Three Mile Island Nuclear Station, Unit 2 (TMI-2)
Operating License No. DPR-73
Docket No. 50-320
Fuel Pool "A" Refurbishment Safety Evaluation Report

Attached are revisions to Section 4.1 and Figure 2.2 of the Fuel Pool "A" (FPA) Refurbishment Safety Evaluation Report (SER). The revision of Section 4.1, "Lifting Operations", deletes the requirement that the upper and lower tanks be empty during lifting operations that use a load path near the Submerged Demineralizer System (SDS). This requirement inhibits present and future lifting operations. The present levels of Sr-90 and Cs-137 in each of the two lower tanks are well below the levels analyzed in the FPA SER for the radiological consequences from a postulated drop of a heavy load into FPA. These levels will continue to decrease through SDS processing. Therefore, the consequence of a load drop into FPA, without the tanks empty, would still be within the bounds of the SER and, thus, present no hazard to the health and safety of the public. This subject was previously discussed between members of the respective staffs on Thursday, November 17, 1983.

TWO SLAB RIGGING SCHEME AND LIFTING BEAM DETAIL	
FMI UNIT 2	
FUEL POOL "A" REFURBISHMENT	
GPU SITE ENGINEERING	
SKETCH - JHA 050283	7
DESIGN: JHA 050283	DATE: 6/7/89
APPROVED: JHA 050283	DATE: 6/7/89

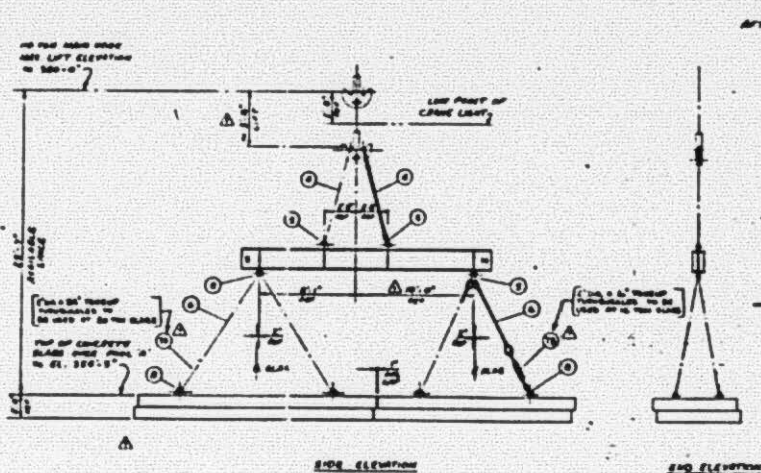
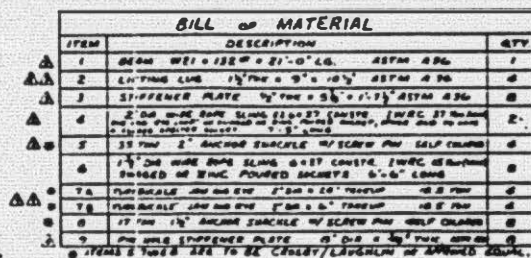
The revision to Figure 2.2, "Two Slab Rigging Beam", reflects the replacement of a 2 inch diameter by 24 inch takeup turnbuckle with a 2 inch diameter by 6 inch turnbuckle. The 6 inch turnbuckle achieves the clearance necessary for the Fuel Handling Building crane to lift and transport the concrete slabs. The rated capacity of the 6 inch turnbuckle is the same as the 24 inch turnbuckle and is, therefore, within the constraints of the FPA SER.
